LIST OF PROPOSED CHANGES:

THE MEADOWLANDS - PROPOSED SITE PLAN CHANGES

BUILDING 1 & 2
 PROPOSED CHANGES - FLOOR PLAN

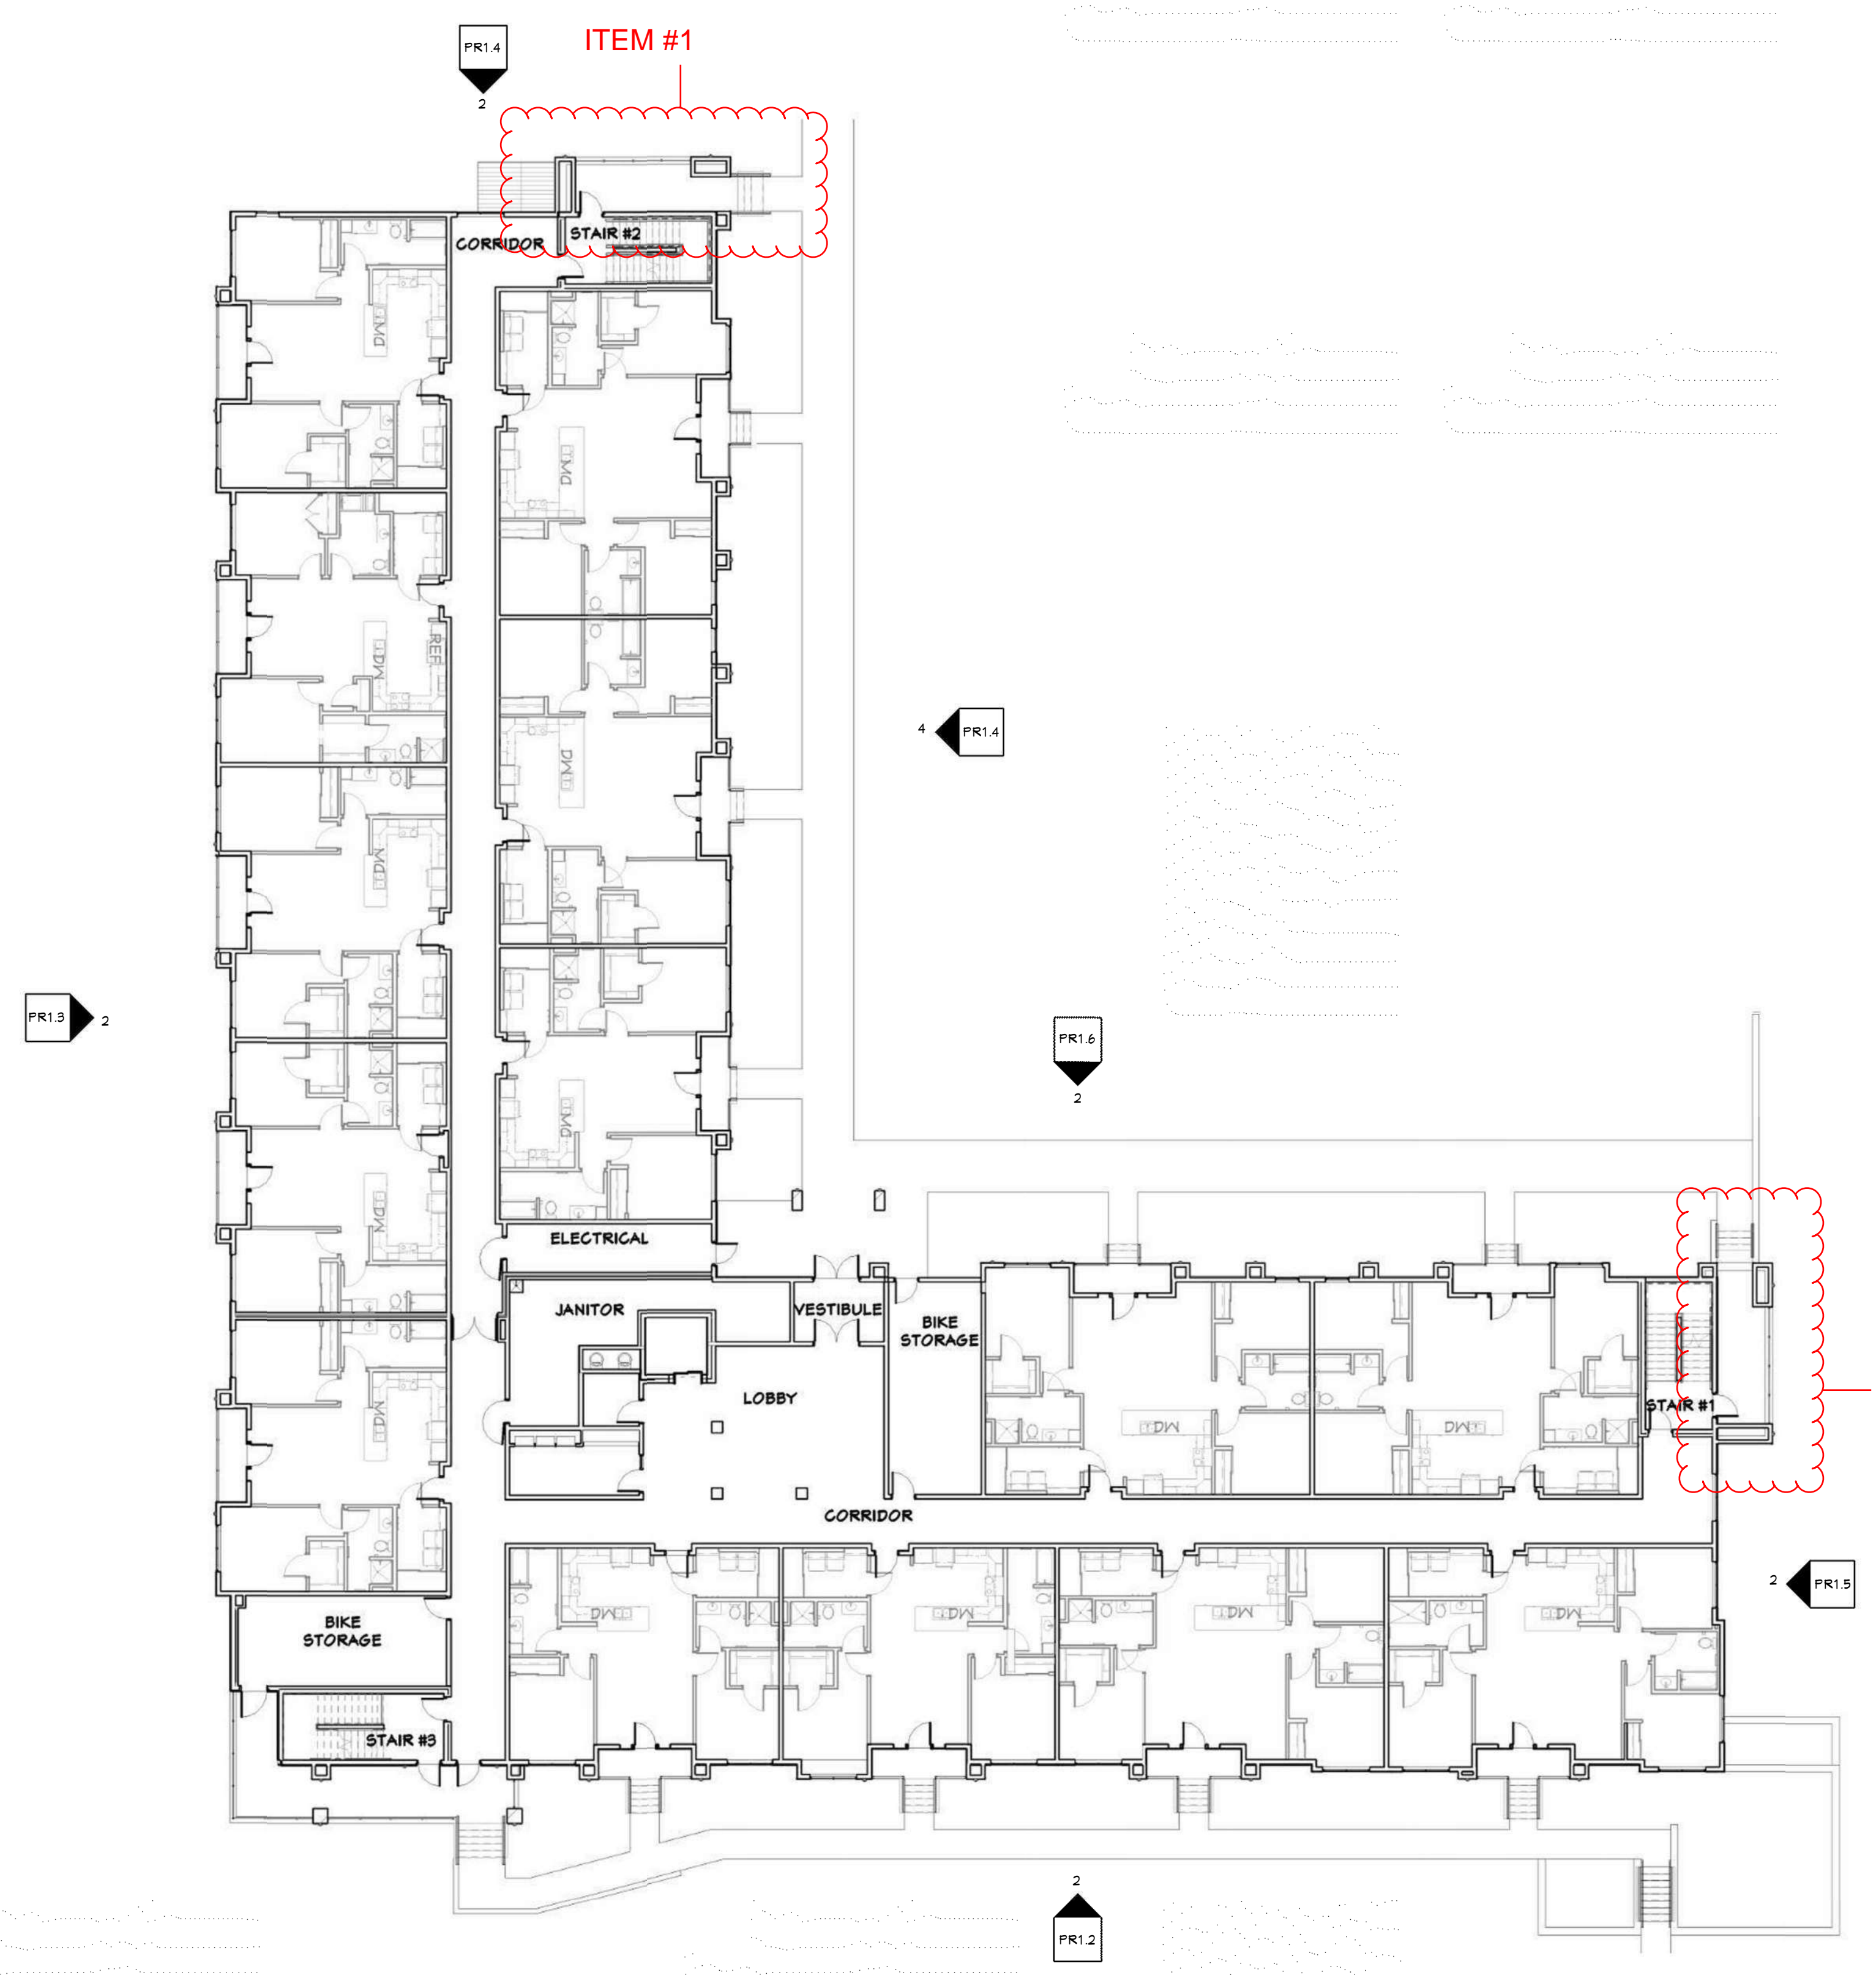
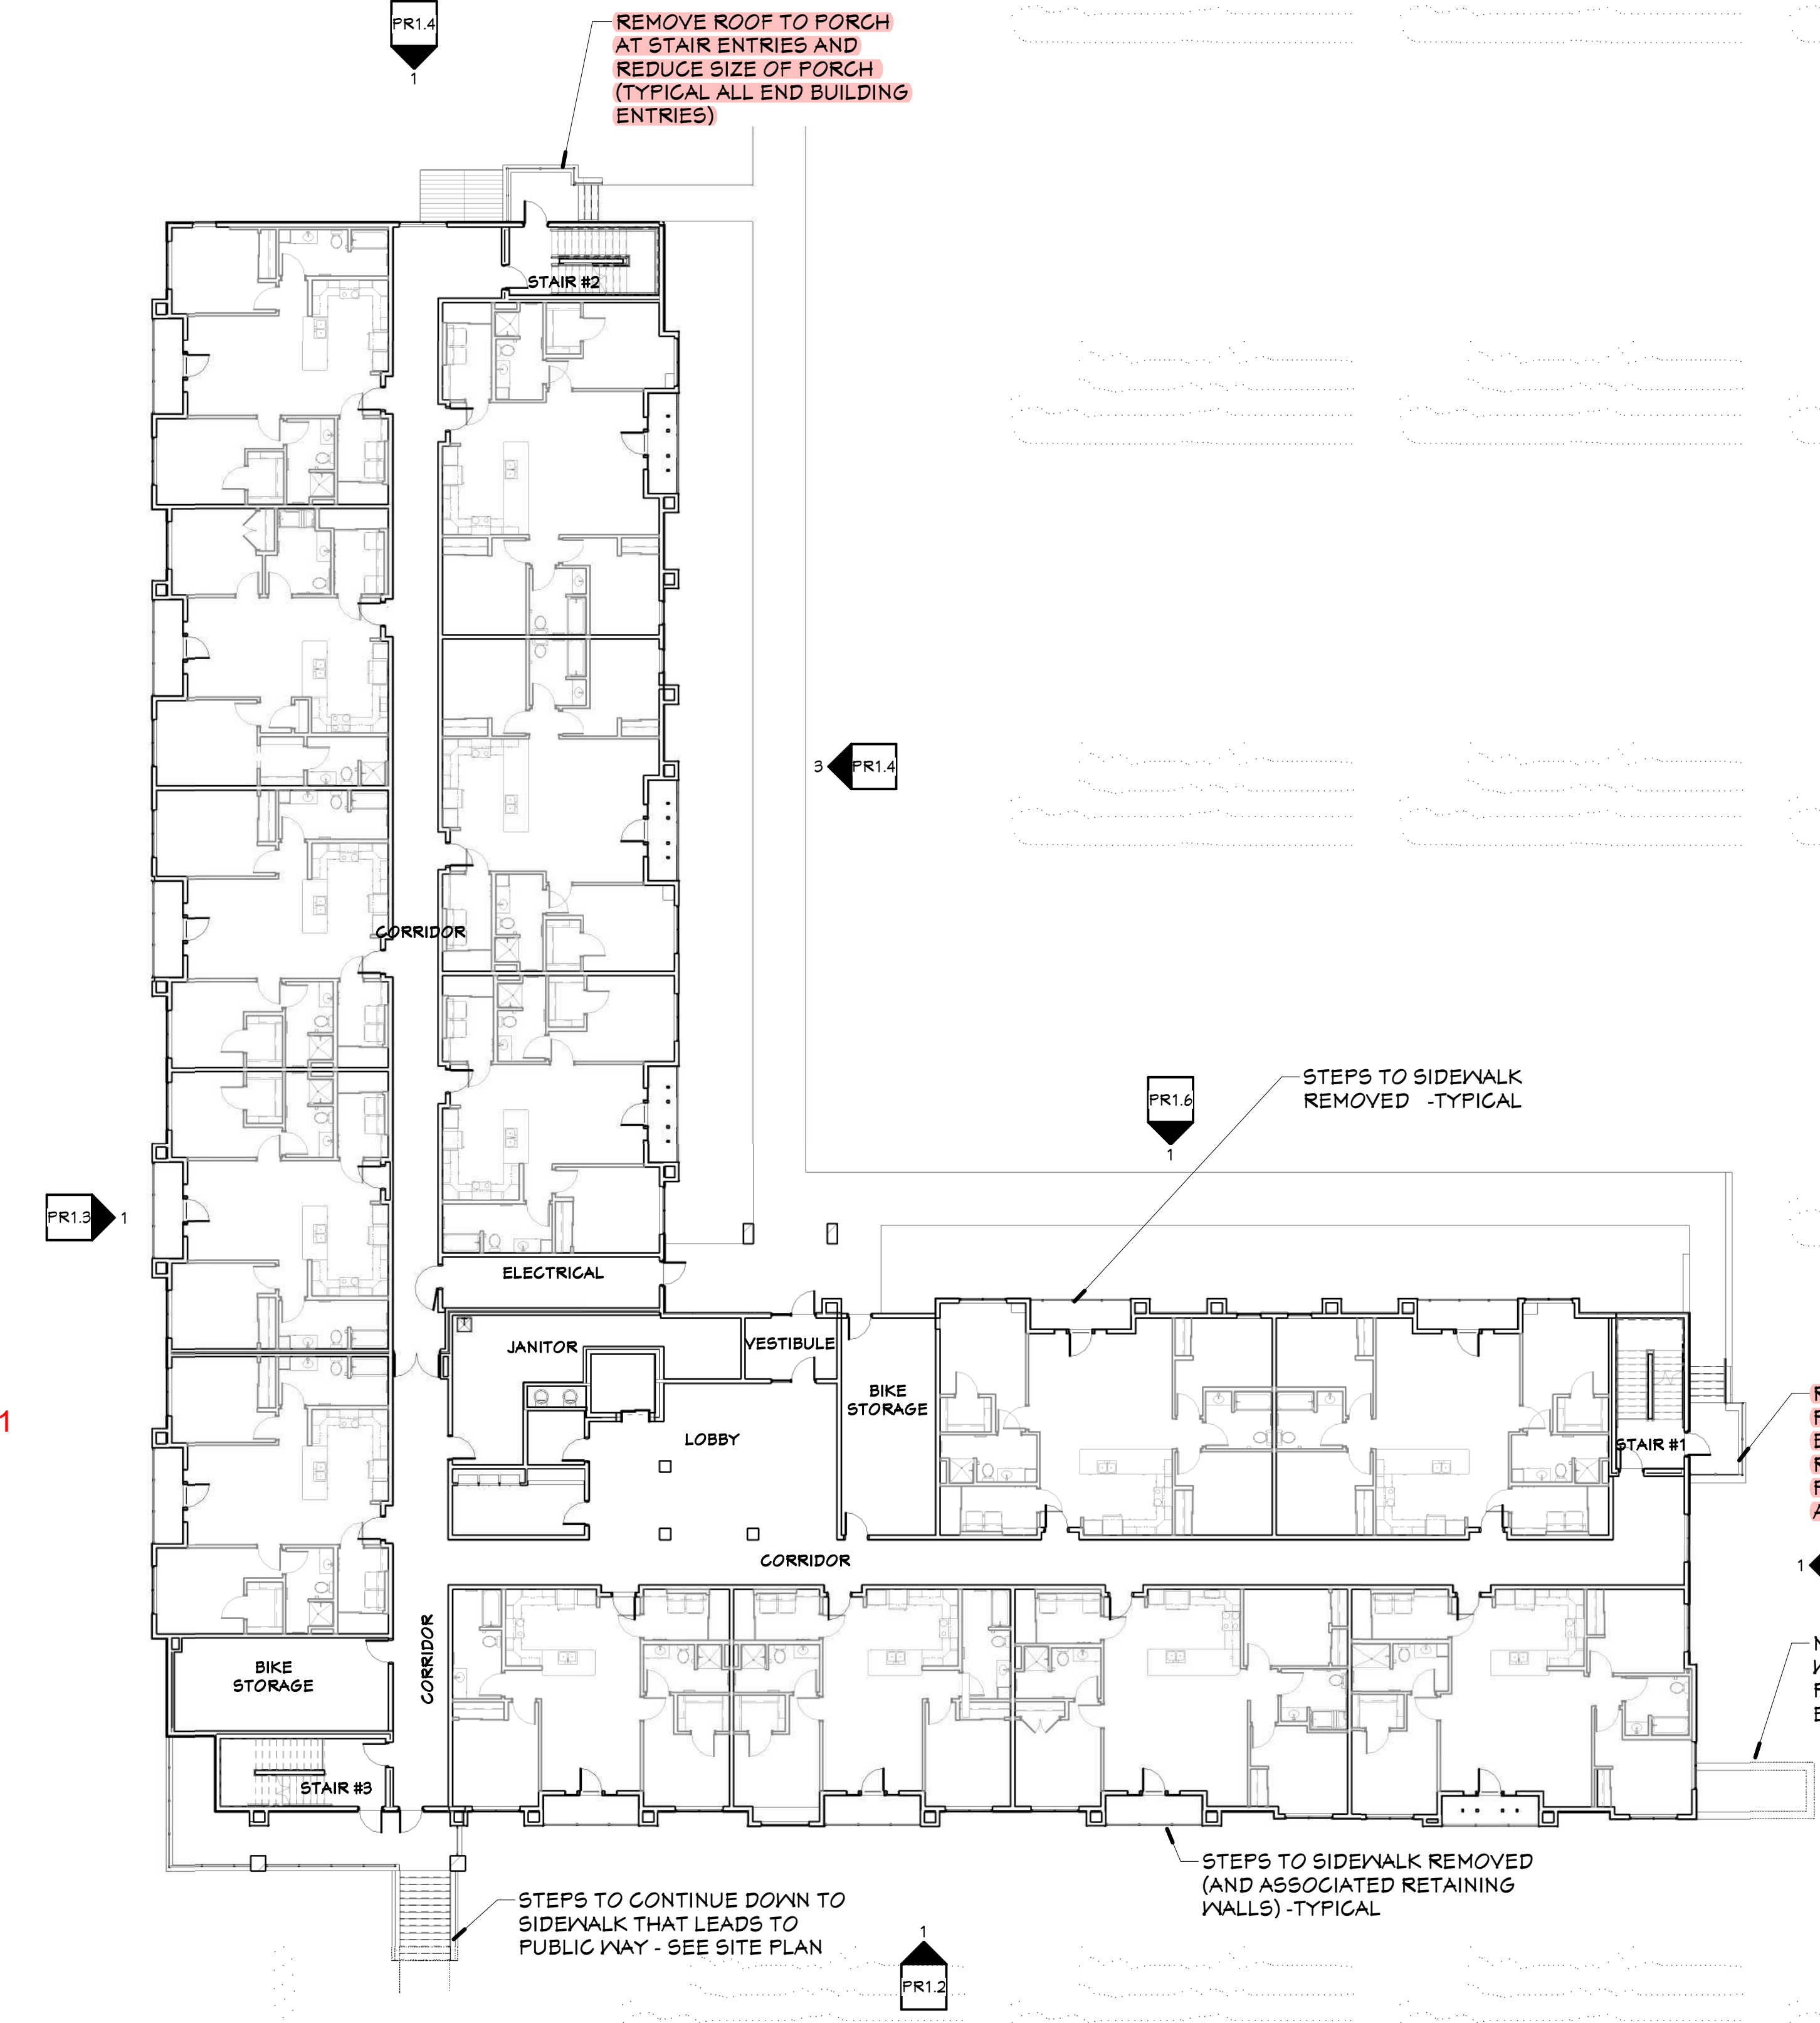
ITEM 1
 REMOVE ROOF TO PORCH AT STAIR ENTRIES AND REDUCE PORCH SIZE (TYPICAL OF ALL END BUILDINGS).

ITEM 4:
 REMOVE STEPS LEADING TO PRIVATE FIRST FLOOR PATIOS AND THE ASSOCIATED RETAINING WALLS AND SIDEWALKS.
